SUBJECT: Additional Information - TMI Unit 1 25<sup>th</sup> Year Reactor Building  
Tendon Surveillance Report

Three Mile Island, Unit 1 (TMI Unit 1)  
Operating License No. DPR-50  
NRC Docket No. 50-289

Enclosure: 1) Three Mile Island Unit No. 1, 25<sup>th</sup> Year Reactor Building Tendon Surveillance  
(Period 7), Topical Report No. 136, Revision 1, July 31, 2001

Figure 1  
Vertical Tendon Force Trend

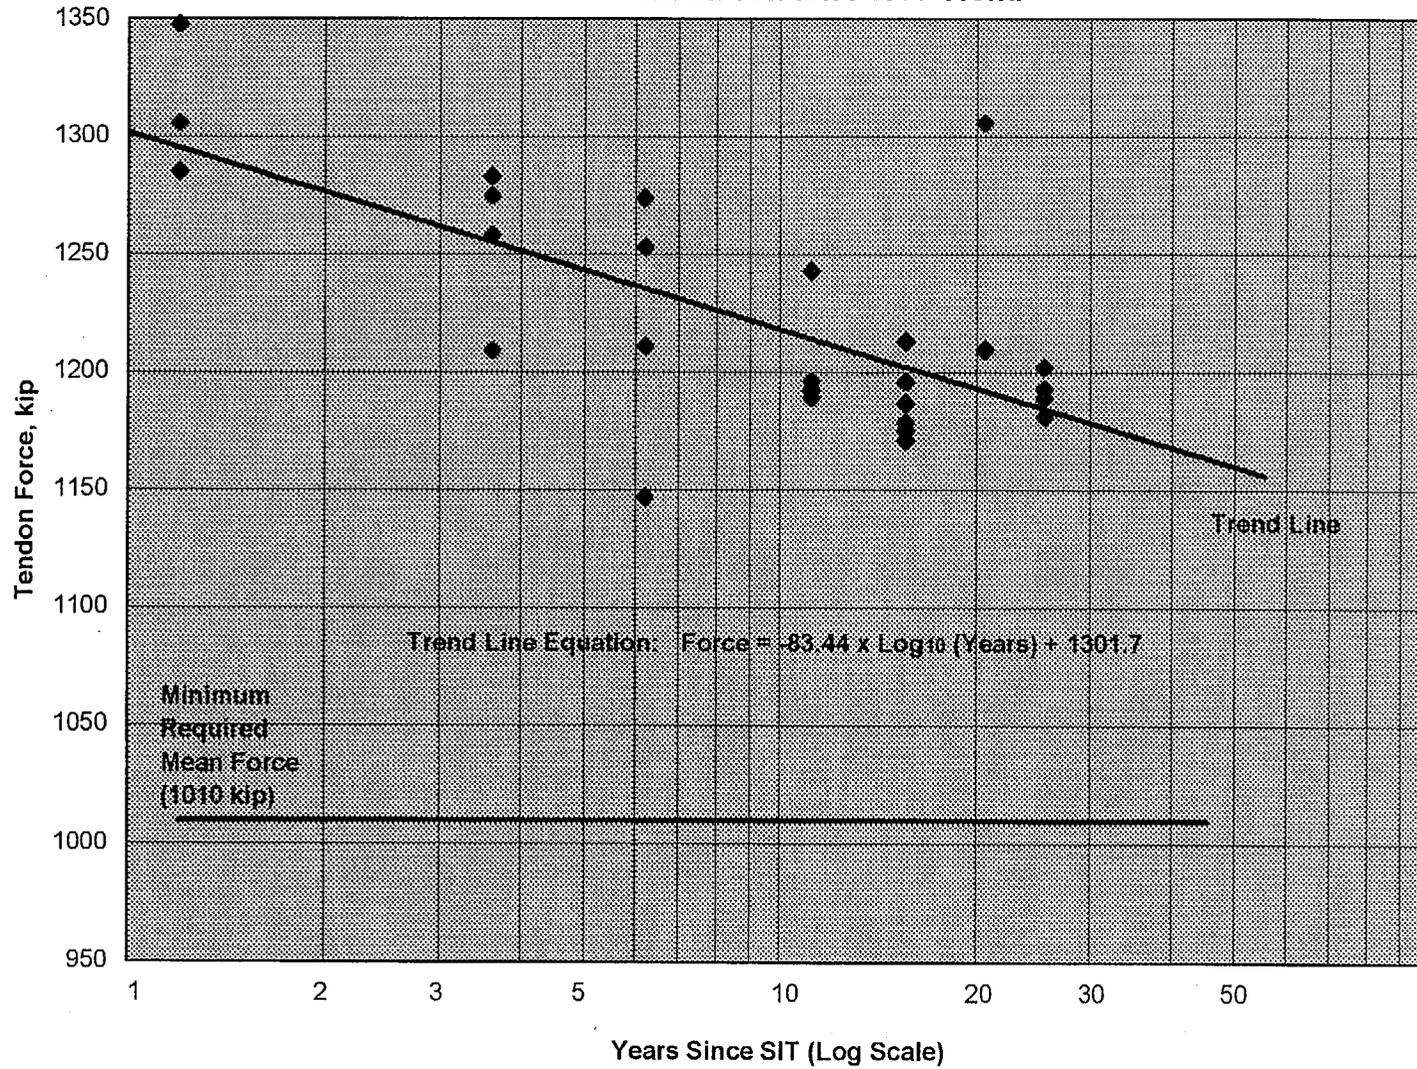
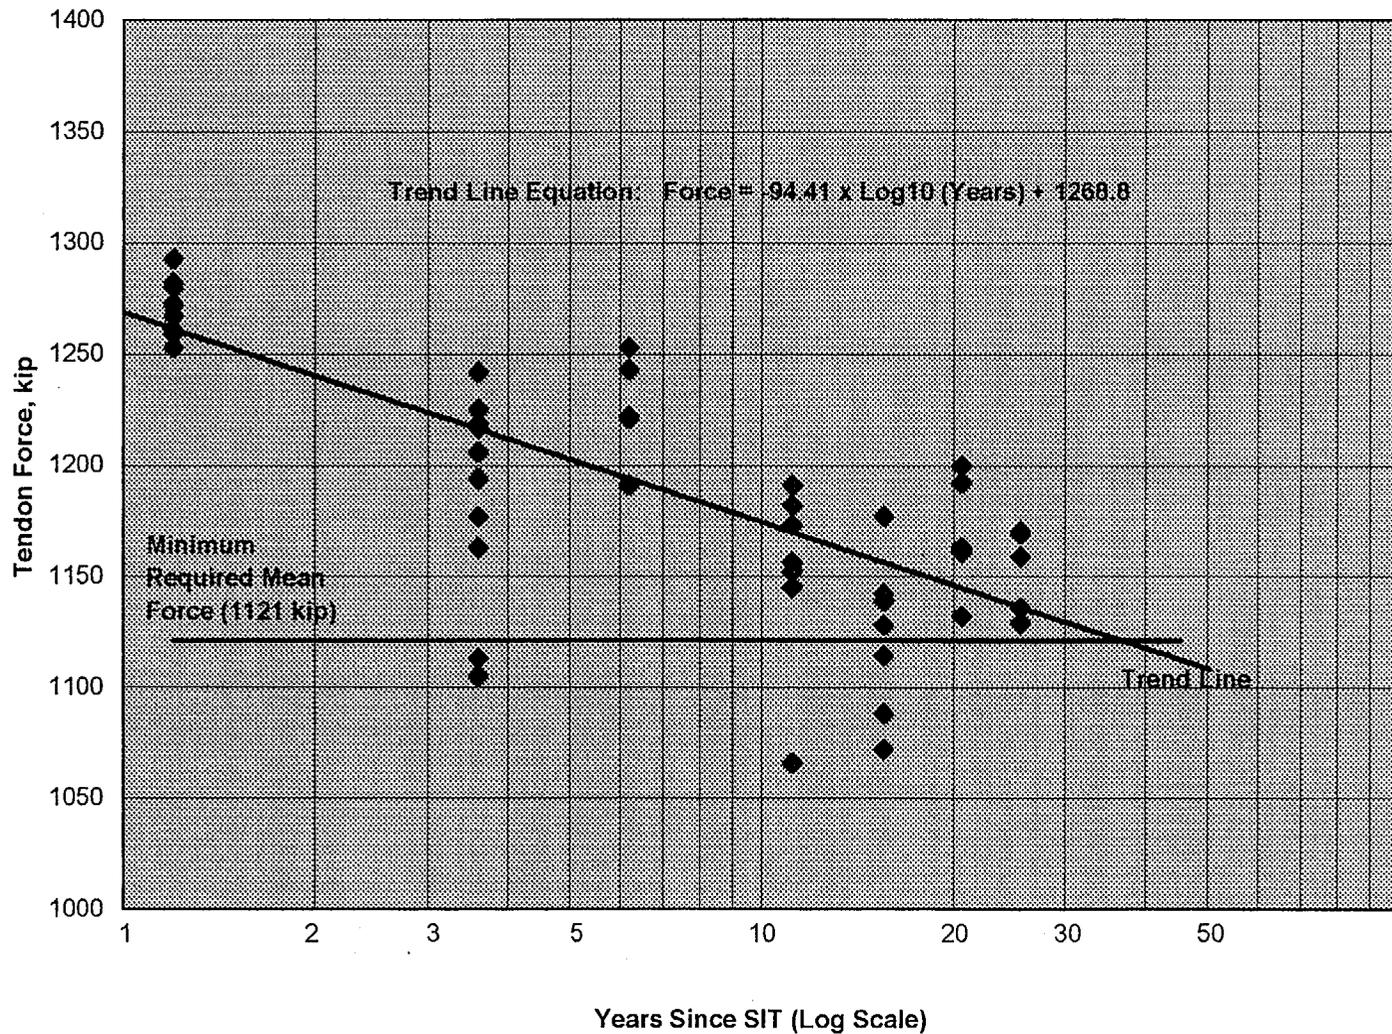
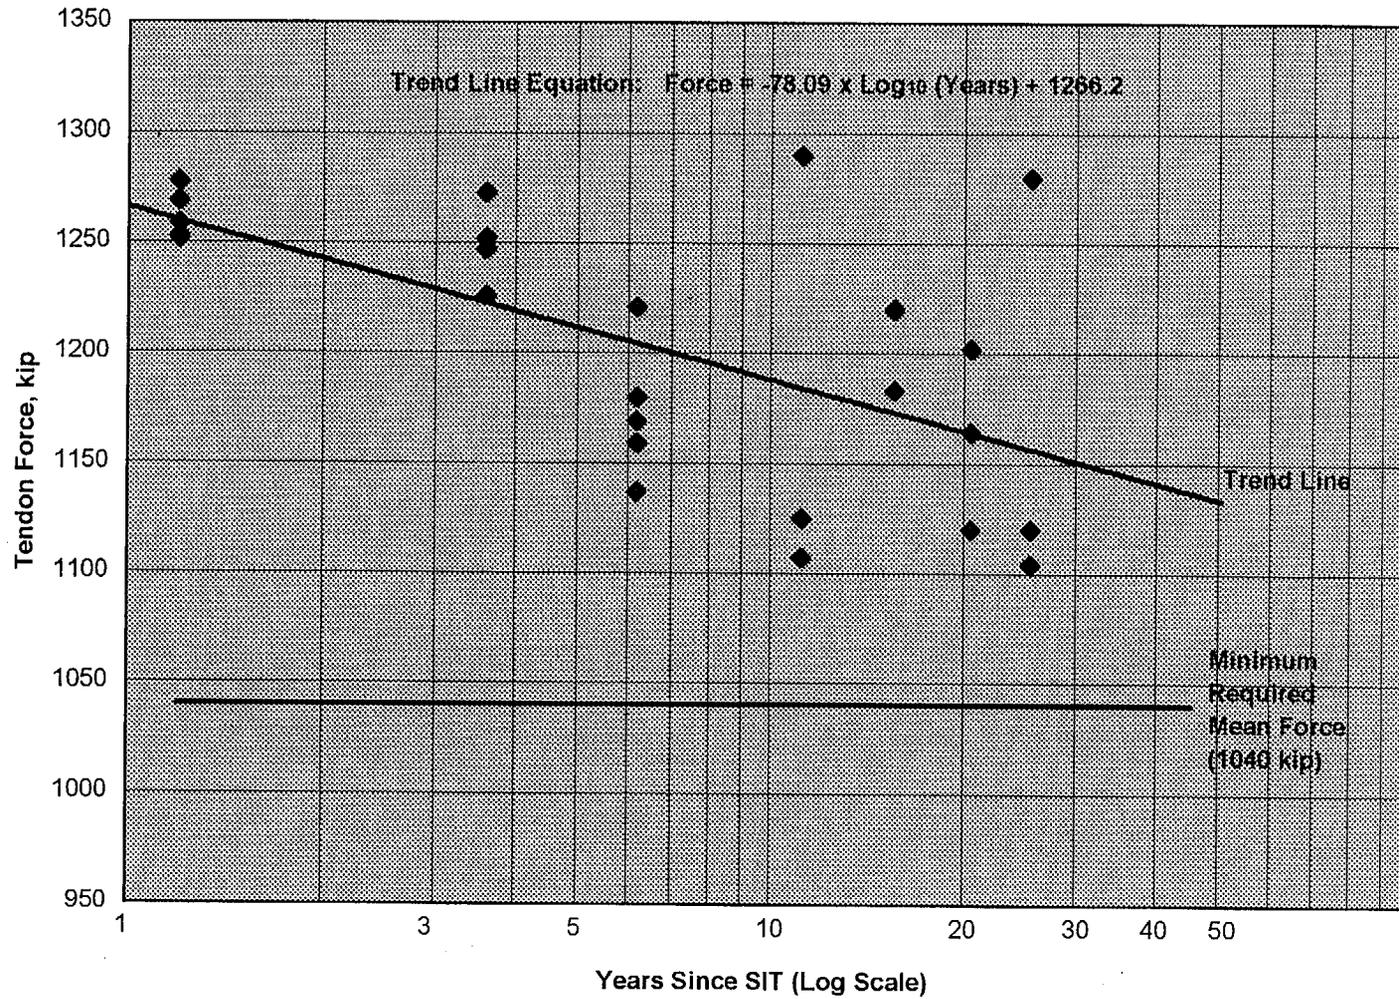
In a conference call on March 7, 2001, the NRC questioned the approach of applying normalizing forces to the individual as found tendon lift-off forces when plotting the vertical, hoop, and dome tendon forces vs. time trend plots in Attachment 1 to the TR. In response to the NRC's request enclosed is TR No. 136, Revision 1, in which the normalizing forces have been removed. The conclusions of the report are unchanged.

<b>AmerGen</b>		DOCUMENT NO.	
		TR 136	
TITLE 25 <sup>th</sup> Year Reactor Building Tendon Surveillance (Period 7)			
REV	SUMMARY OF CHANGE	APPROVAL	DATE
00	Initial Issuance		
01	<p>TMI-1's past practice of applying the normalizing force to Figures 1, 2, and 3 of Section 5.4, "Tendon Force Trends" has been questioned by the reviewer. The reviewer has indicated that TMI is an outlier in the industry, as TMI-1 applies the normalizing force to its individual as-found tendon lift-off forces when plotting the vertical, hoop, and dome tendon forces vs. log of time trend plots. As such, TMI-1 has concurred with the reviewer's request to remove the normalizing force for plotting the force vs. time trend plots, and resubmit the report and all affected portions therein for AMERGEN resubmittal to NRC. Also, TMI-1 has revised Figures 4, 5 &amp; 6 (Control Tendon Trends) to show measured force rather than normalized force. This revision includes several editorial corrections in addition to the substantive changes described.</p> <p>As a result of this change, Attachment 1 to this report has been revised, and supercedes in its entirety, Revision 00. All other portions of the report remain unaffected by this change.</p>	<p> Howard T Hill</p> <p>J T Liu </p> <p>John J Piazza </p>	<p>24 JUL 01</p> <p>07/31/01</p> <p>7-31-01</p>

As discussed in Section 5, tendon forces documented in the reports covering the 10<sup>th</sup>, 15<sup>th</sup> & 20<sup>th</sup> Year Surveillances are adjusted to provide a correct basis for trending. As a result, there are numerous differences between the forces documented in those earlier reports and those used to compute trends in this report. Addendum sheets will be added to the 10<sup>th</sup>, 15<sup>th</sup> and 20<sup>th</sup> Year Surveillance reports to clarify this issue. The addendum sheets will refer to this report for correct force values and an explanation of the adjustments.
